City of Mississauga Department Comments

Date Finalized: 2022-07-13 File(s): A301.22

The applicant requests the Committee to approve a minor variance to allow the construction of an accessory building (pavilion) proposing:

Property Address: 1586 Jalna Ave

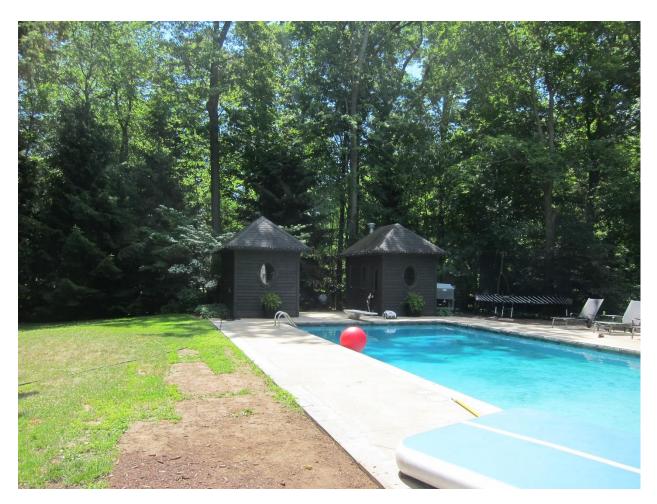
Enclosed are photos of the existing structures in the location where the new structure is proposed. We are noting for Committee's information that any Transportation and Works Department concerns/requirements for the proposed accessory structure will be addressed by our Development Construction Section through the future Building Permit process.
